NOTICE OF QUALIFICATION FOR PERMIT VARIANCES IN RESPONSE TO PROJECT CHANGES REGARDING THE CLEAN WATER ACT SECTION 401 WATER QUALITY CERTIFICATION FOR THE SOUTHERN CALIFORNIA EDISON TEHACHAPI RENEWABLE TRANSMISSION LINE PROJECT, SEGMENTS 7 AND 8, LOS ANGELES AND SAN BERNARDINO COUNTIES, CALIFORNIA

### **TRTP: SEGMENT 7&8 NOTICE OF QUALIFICATION FOR PERMIT VARIANCES IN RESPONSE TO PROJECT CHANGES**

#### **DESCRIPTION OF VARIANCE ACTIVITIES**

**Figure 1**  
**Potential Impacts to Jurisdictional**  
**Feature 7-3-S-1 at M27-T3**  
**Tehachapi Renewable Transmission Project**

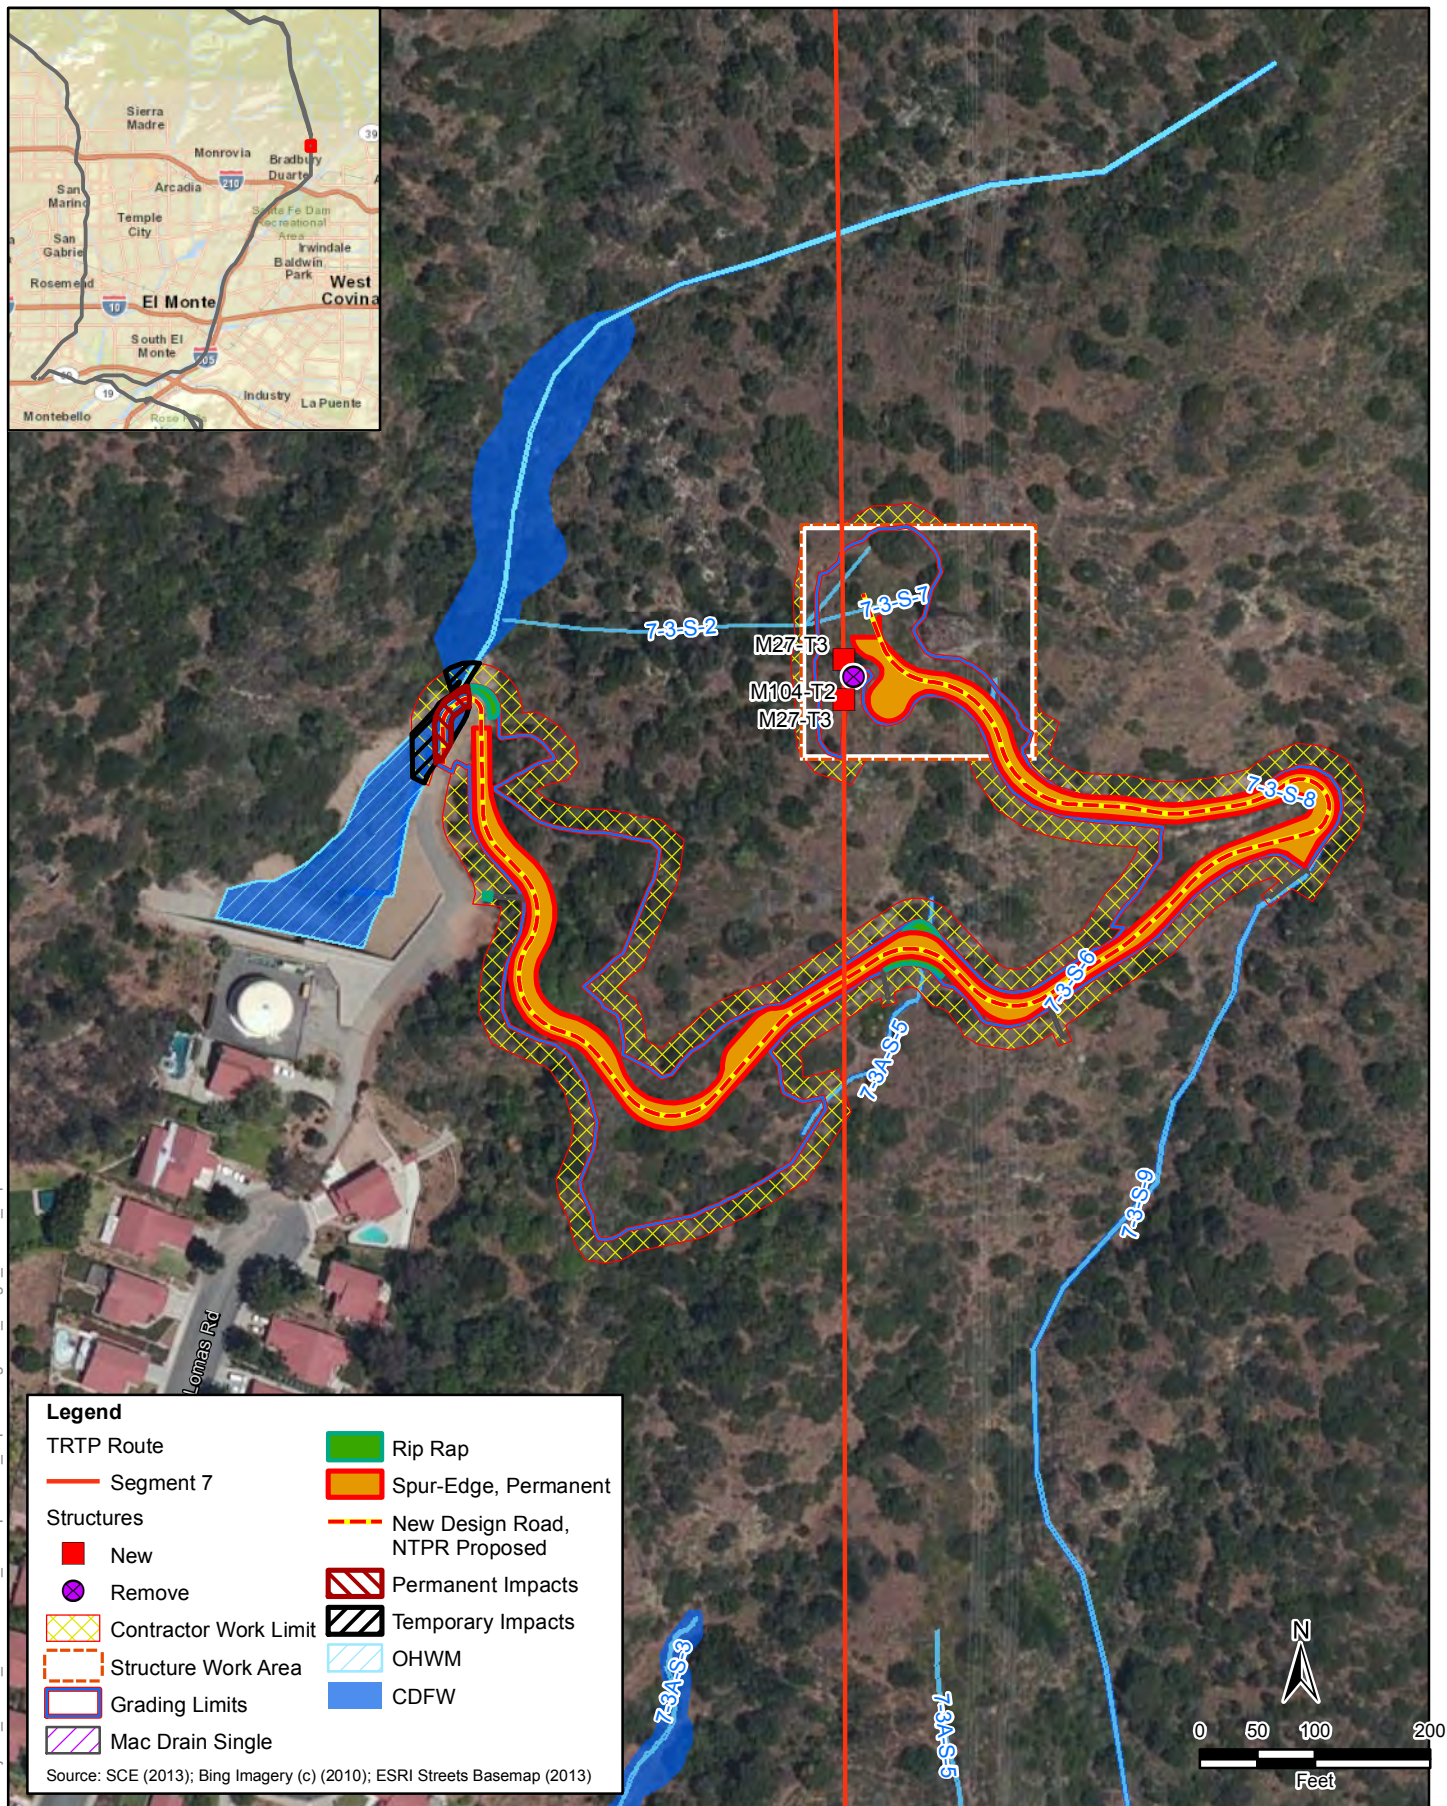
SCE proposes to install a concrete wet crossing within an existing debris basin in order to reduce future maintenance in the basin and to provide a more stable driving surface and safe approach for construction as well as O&M vehicles to access TRTP Segment 7 Structure M27-T3. The proposed project site is located in a debris basin at the base of the foothills in the City of Duarte. The basin is operational and maintained by the Los Angeles Department of Public Works. The basin is unvegetated as a result of this ongoing maintenance but upstream portions of the feature (to the north) contain southern coast live oak riparian forest. Steep hillsides on both sides of the basin are mapped as coastal sage scrub and coast live oak woodland. Urban development is located to the south.

Impacts related to the proposed variance activity include 0.02 acre and 44 linear feet of permanent impacts and 0.04 acre and 70 linear feet of temporary impacts to waters of the U.S. This results in a total of 0.06 acre and 114 linear feet of impacts to waters of the U.S. The proposed activity involves the discharge of clean-native fill material, concrete and rip-rap to a streambed waterbody within the San Gabriel River watershed. Inflows to the debris basin originate from upstream unnamed ephemeral tributaries and outflows are routed via a storm drain outlet located within the existing debris basin. These impacts and conditions are shown in the attached figures.

TEHACHAPI RENEWABLE TRANSMISSION  
PROJECT (TRTP) - SEGMENT 7  
POST-DEVELOPMENT CONDITION  
TOWER M27-T3

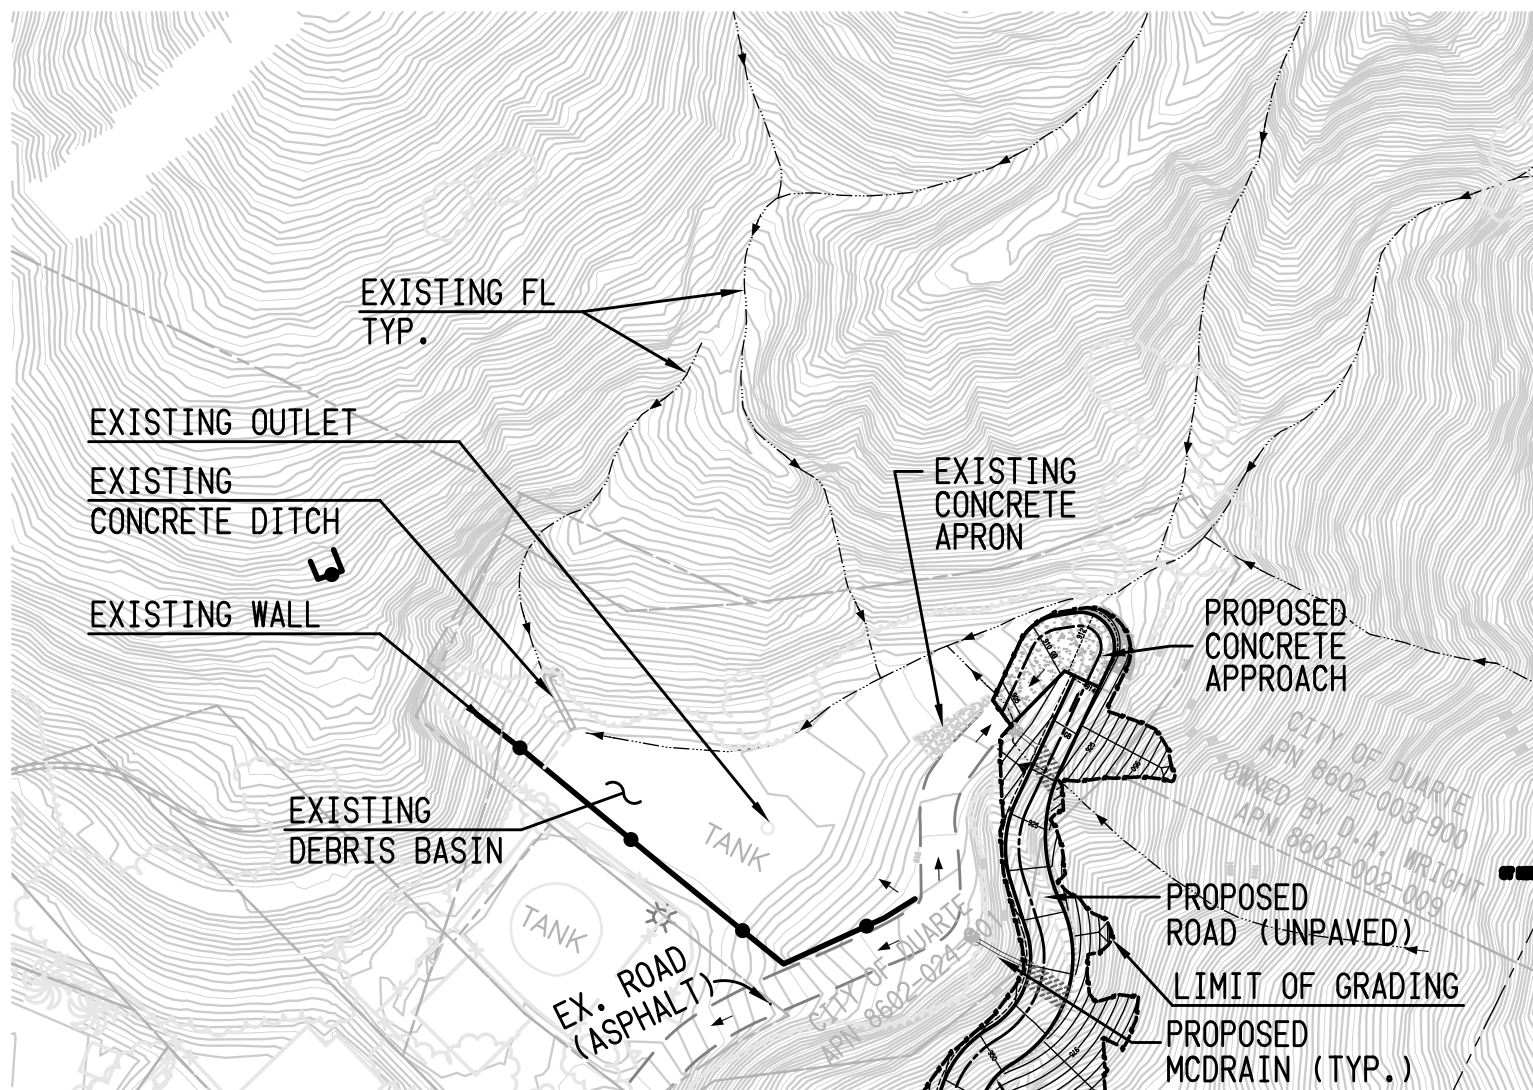
The existing access road is currently at too steep of a grade and in very poor condition, making it impassable for both construction and O&M access. The current concrete approach stops at the edge of the detention basin, creating an unsafe turning radius on the existing dirt access road. The proposed extension of the existing concrete approach will be essentially at current grade elevations with no impact to the basin's retention capacity. Using a natural surface (unpaved) for the approach would require increased annual maintenance in the basin to remove ruts, uneven surfaces, may expose the SCE access road to increased erosion potential during heavier rain events, and would cause increased sedimentation immediately downstream of the crossing.

The proposed grading and concrete approach to the access road will maintain existing drainage patterns. Under existing conditions, the runoff upstream of the approach to the access road is directed through the flowline at the base of the west side of the debris basin and then continues into the bowl or main storage area of the basin. The basin drains via the county flood control outlet and channel. Under proposed conditions, the runoff will continue its current course. The extension of the existing concrete drive approach along the east side (high side) of the basin will remain outside of the main flowline of the basin. The new concrete approach will be installed from the edge of the existing concrete to the start of the realigned existing access road approach which will be repaired to its original width. The upstream side of the crossing will be lined with rip-rap (rocks 12 to 36 inches in diameter) in order to protect the drive approach and reduce the potential for undercutting of the concrete.
